MEMORANDUM

From:	Gordon Adam Development Control		
Service	SDL Highways	App No:	250399
Address:	Parcel R10 South Wokingham, Phase 2b, Parcel R10.		
Proposal:	Application for the approval of reserved matters pursuant to condition 1 of outline planning permission ref. 191068 for the erection of 215 dwellings with layout, scale, appearance, and landscaping to be considered.		
Type of Development:	Major Dwellings (10+)		
Site Visit Made:	Yes/No

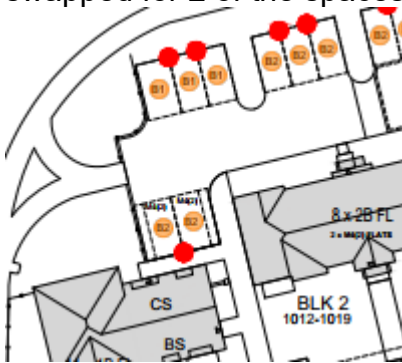
1. Highways understands that this is a RM application for 215 dwellings as phase 2 of delivering the South Wokingham SDL which was approved under 191068.
2. Highways welcomed the opportunity of providing pre-application comments.
3. This application is supported by a transport statement.
4. Please ensure that all plans submitted individually and within the transport statement are the same. It appears that the proposed parking plan is not aligned with the housing mix proposed in the TS

- 40. Drawing A389-091 Rev P2 has been submitted which is welcome.
- 41. If there are any recommended changes to the layout agreed as part of this application, will need to be reflected in this drawing

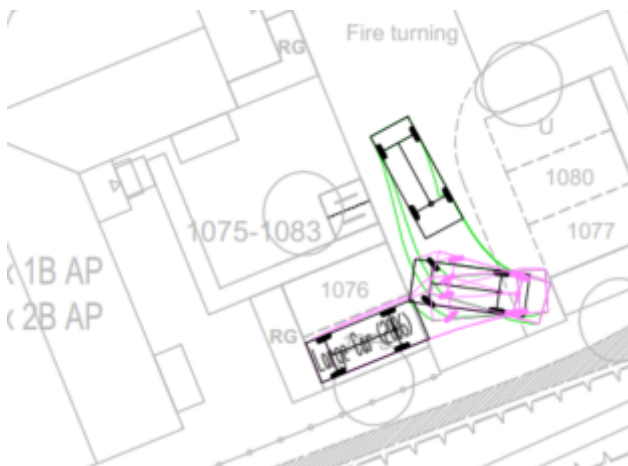
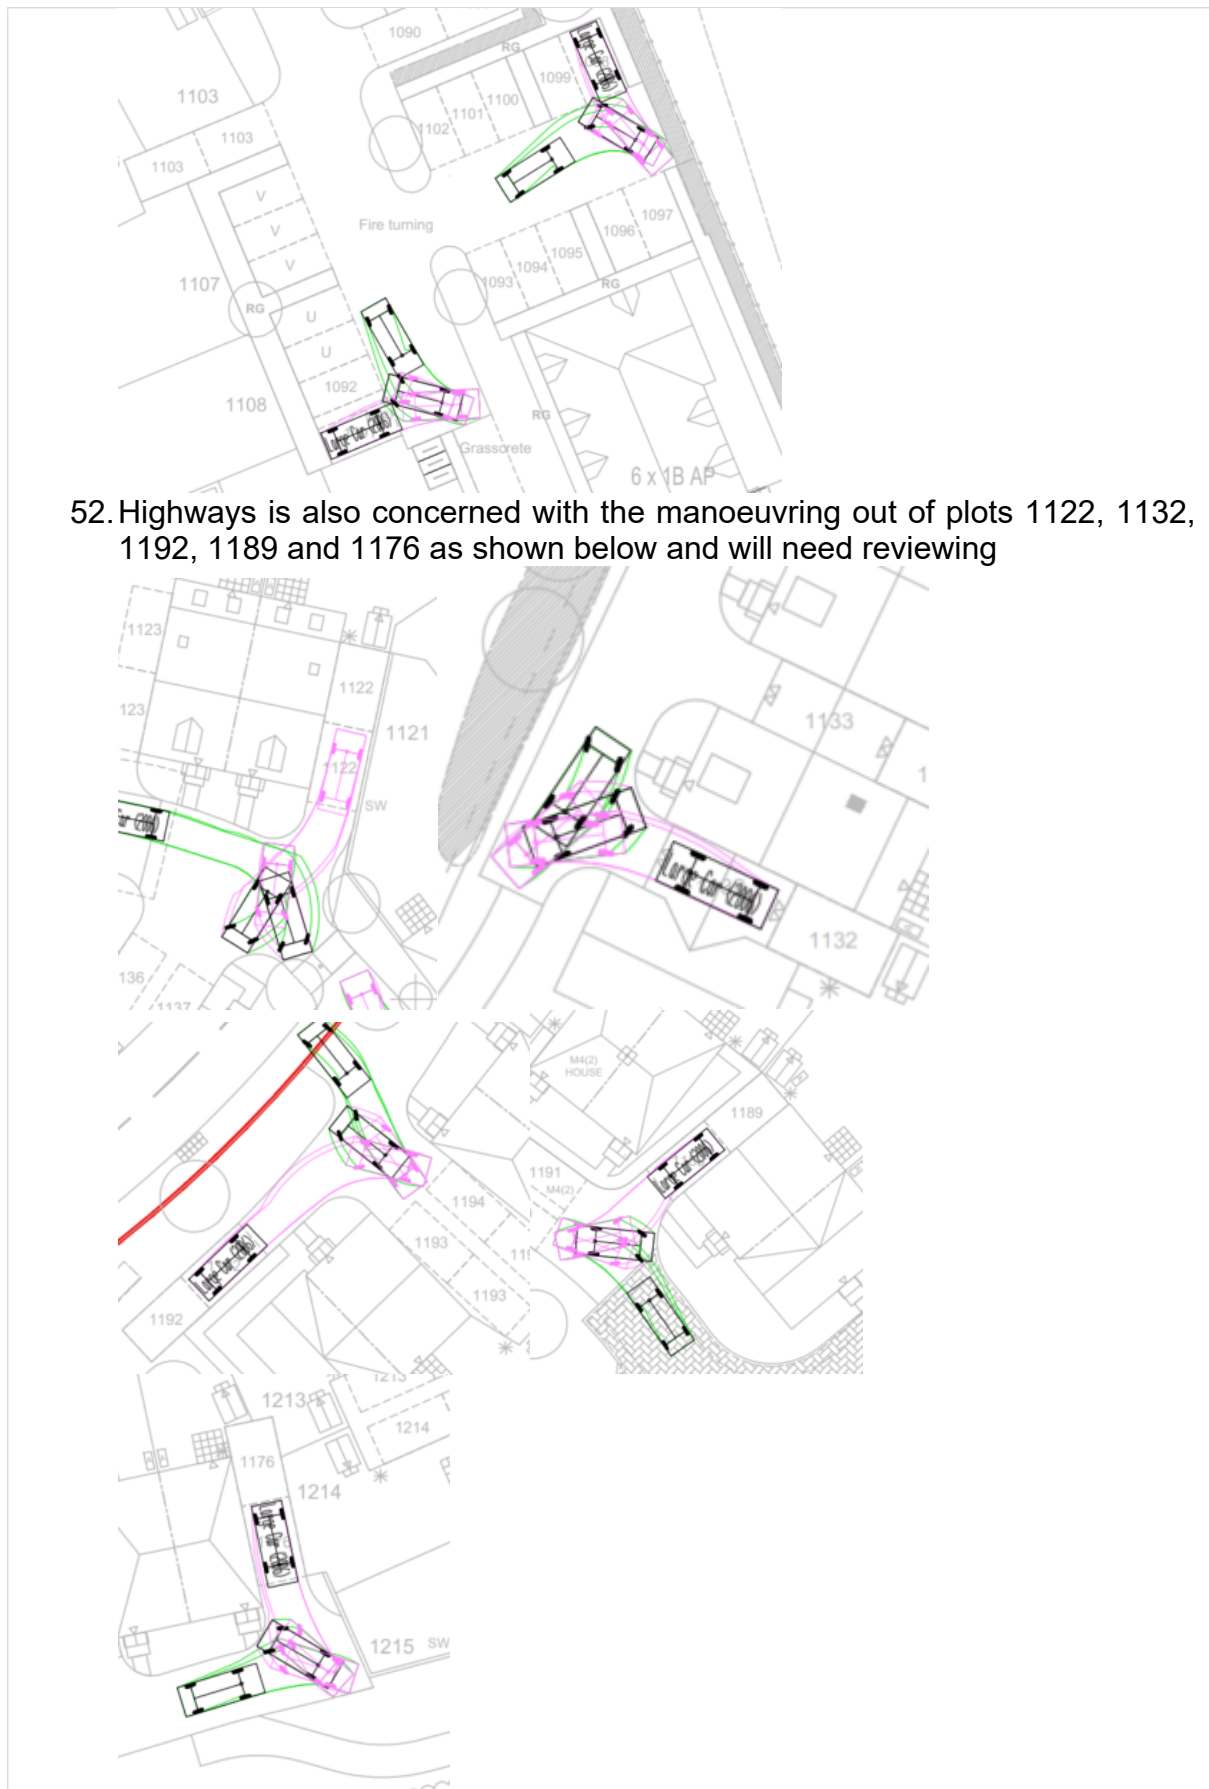
- 42. Whilst, in principle, this drawing reflects what has been included in the approved Pedestrian and Cycle Strategy, however, highways would recommend the following changes to the submitted plan, namely: -

- a. It would be better if pedestrian only routes would be coloured differently to those of the shared use areas.
 - b. All the pavements would need to have a different colour.

- c. The access via Waterloo Road should have an arrow to depict a vehicle access rather than a primary street.
 - d. The R10/R14 link road is classed as a secondary street with a bus route within the approved strategy and not a primary street

- e. Please include that Waterloo Road is close from the southern access to the link road as shown in the approved Walking and Cycling Strategy

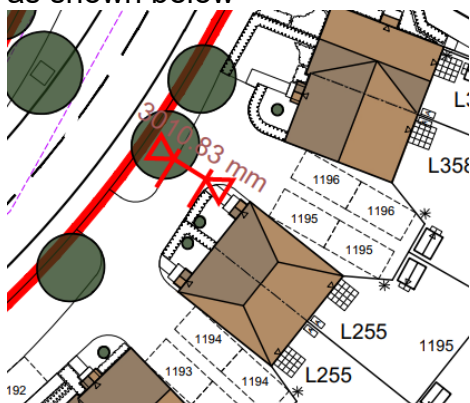
75. A proposed adoption plan (Drawing A389-R10-RM-103 Rev A) has been submitted which is welcome. Highways would recommend that the access roads to the rear of Blocks 1 to 4 are excluded from the adoption plan and the demarcation is moved closer to the spine road.

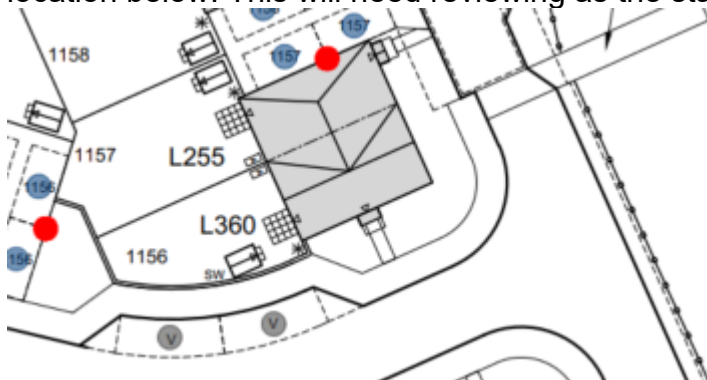
84. The width of the private road outside plot 1195 needs to be 4.1m and not 3m as shown below
